SEPP 65

A complete SEPP 65 assessment has been undertaken and is within the following table. The development generally complies with the intent and controls of SEPP 65, however seeks variations to the following elements of the ADG:

WINTER SOLSTICE | 3 PM
21 JUNE 2021

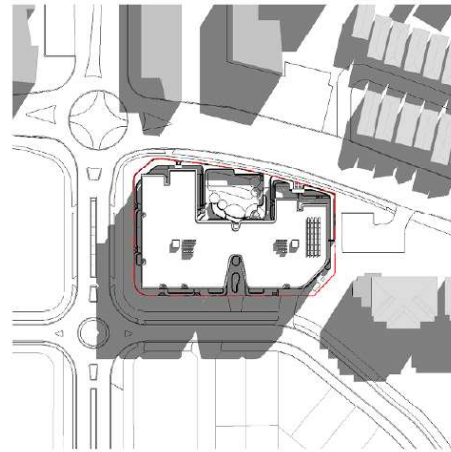
The site contains street frontages to the east, west and south and shares a boundary to the north with a car park and with the Oaks Santai Resort.

Shadows cast by the proposal will generally fall over Casuarina Way, Grand Parade and Blackwattle Circuit and will not result in additional shadowing to the resort to the north. These shadows will fall marginally onto allotments on the eastern side of Blackwattle Circuit however, the extent of these shadows is minimal and will not adversely impact the private open space of any future developments on the affected sites as the shadows will be cast over the frontage of those sites only.

Complies.
